Appl. No. 09/886,829  
Atty. Docket No. 8595  
Amdt. dated March 8, 2005  
Reply to Office Action of December 8, 2004  
Customer No. 27752

## AMENDMENTS TO THE DRAWINGS

Fig. 9

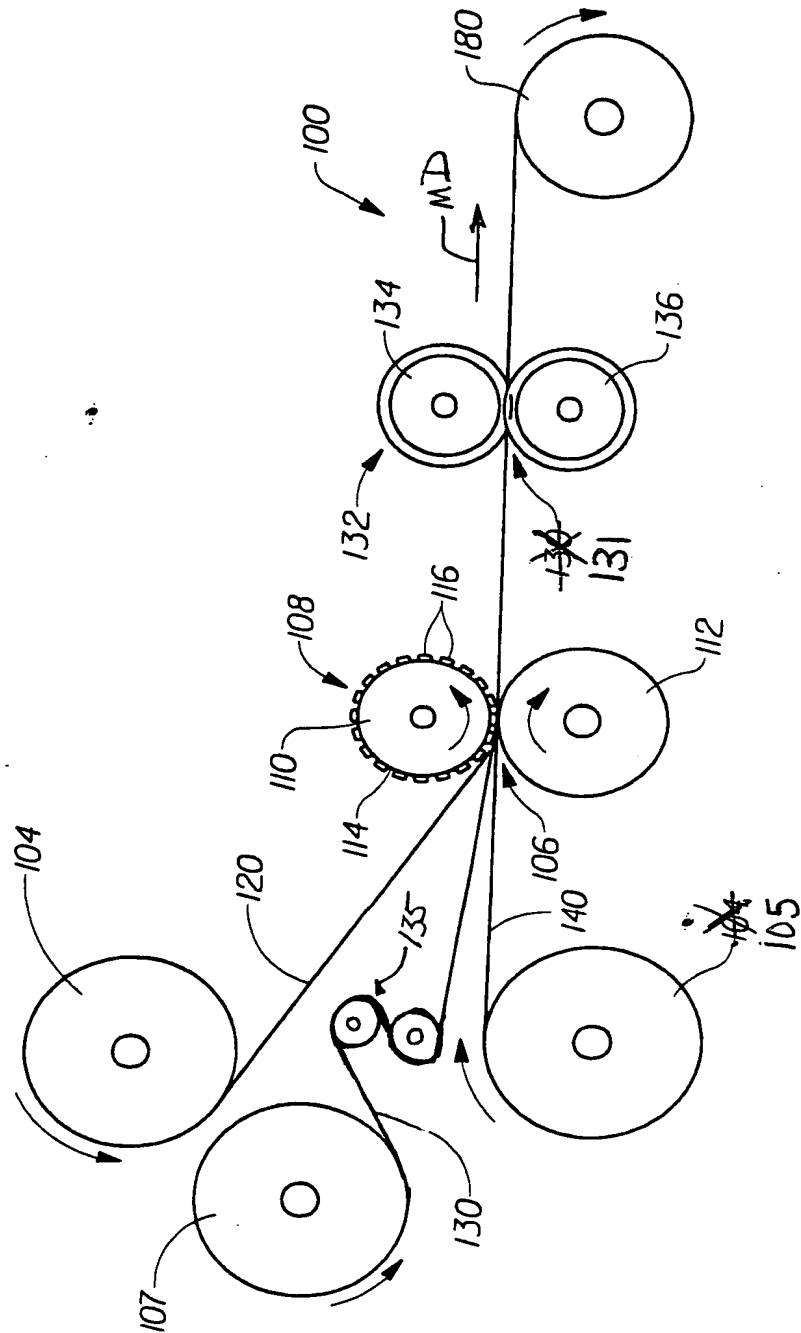
The attached sheets of drawings include amendments to Fig. 9. Character 105 is replacing character 104 for the second (lower) supply roll. The characters now correspond to the description in the specification. Character 131 is replacing character 130 which designates the nip corresponding to incremental stretching system 132. A formal replacement sheet with the corrected characters for Fig. 9 is attached.
